Audit Report

OIG-05-042 (Interim Report)

TBARR: While Progress Has Been Made On The Main Treasury Renovation, Code Violations And Other Deficiencies Need To Be Corrected

July 29, 2005

CONDENSER WATER SYSTEM LAYOUT

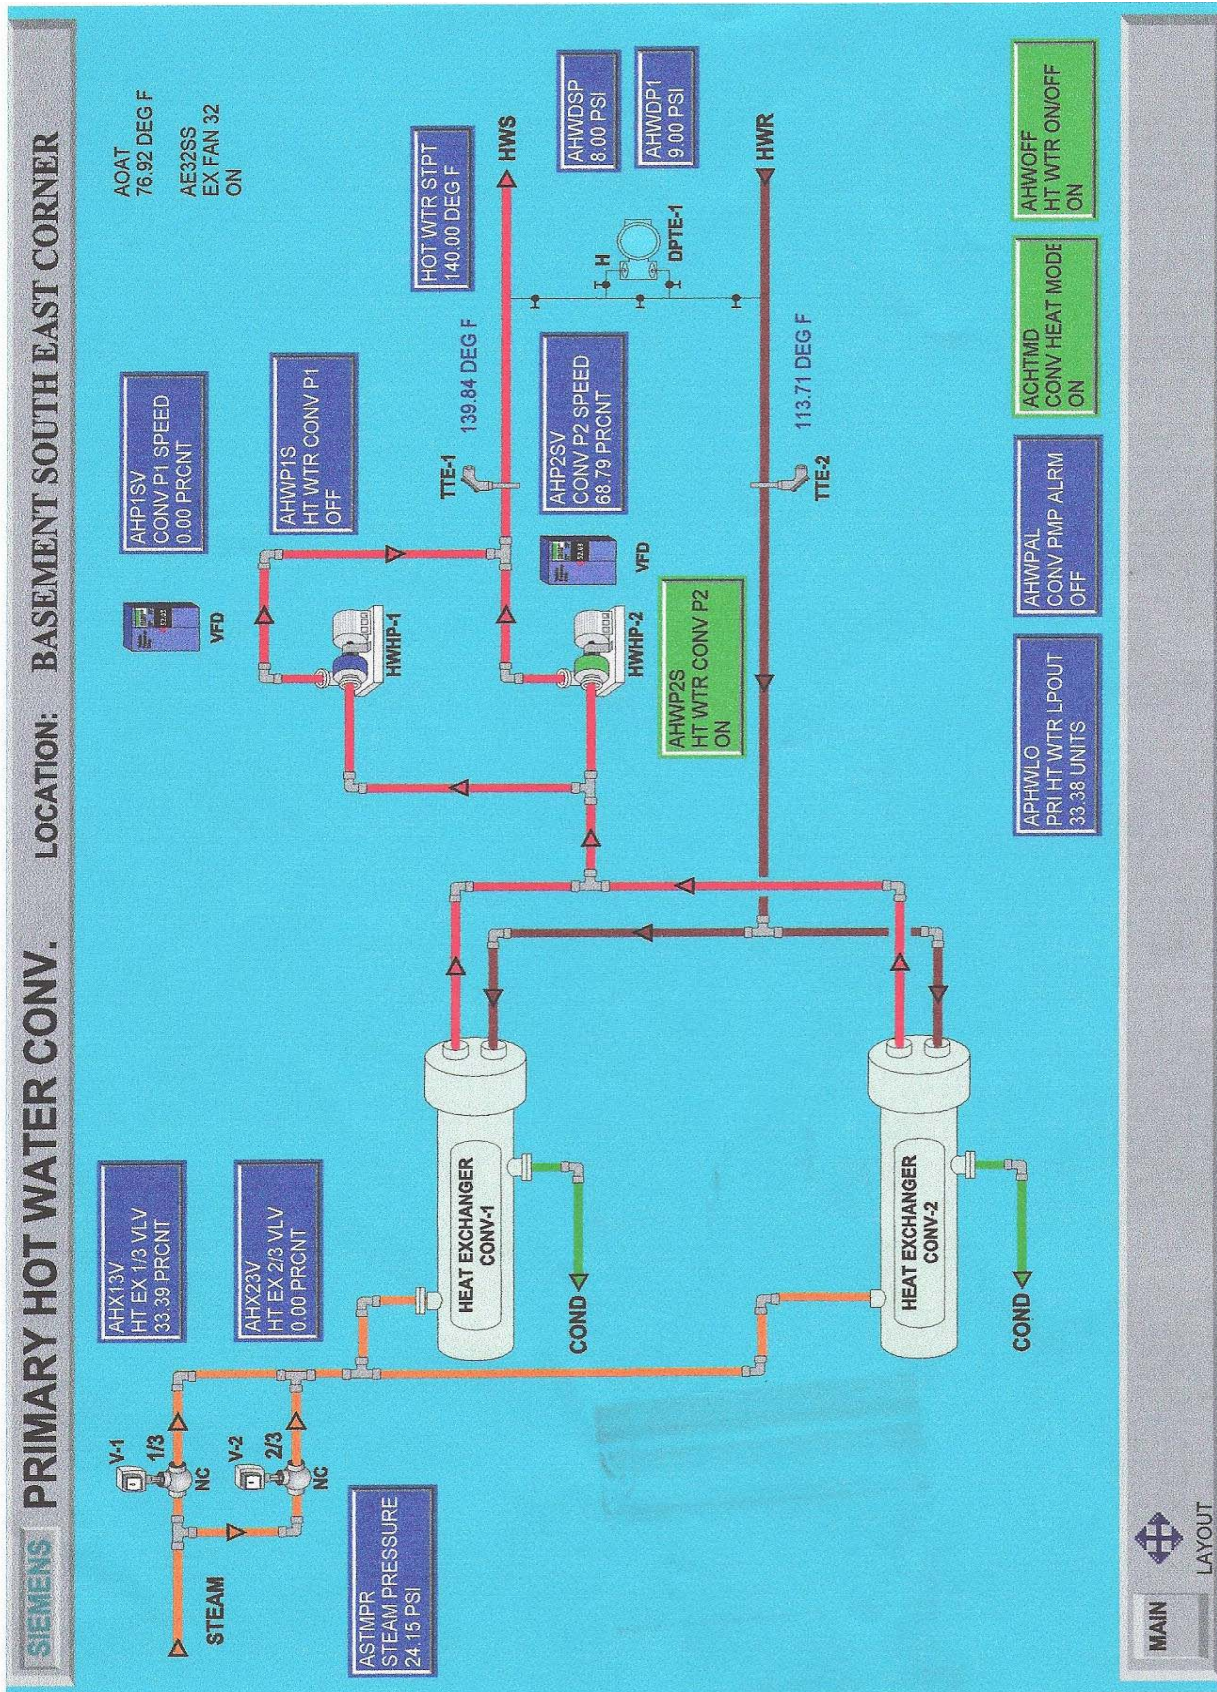
- g. We recommend dedicating a high efficiency chiller to serve all 100% outside air handling units. A chiller would provide 35 degree Fahrenheit chilled water to the air handler cooling coils. At this low temperature the cooling coils would be able to remove most of moisture from the air eliminating a need to heat outside air supply to 70 degree Fahrenheit in order to avoid water condensation outside the supply air ductwork. As an alternate, use of a desiccant wheel in the outside air intake duct could help reduce moisture in the air before it reaches the AHU chilled water cooling coils.

- Mechanical, Recommendation g (Page 5) CMDR recommended dedicating a high efficiency chiller to serve the outside air handling units, which would remove most of the moisture from
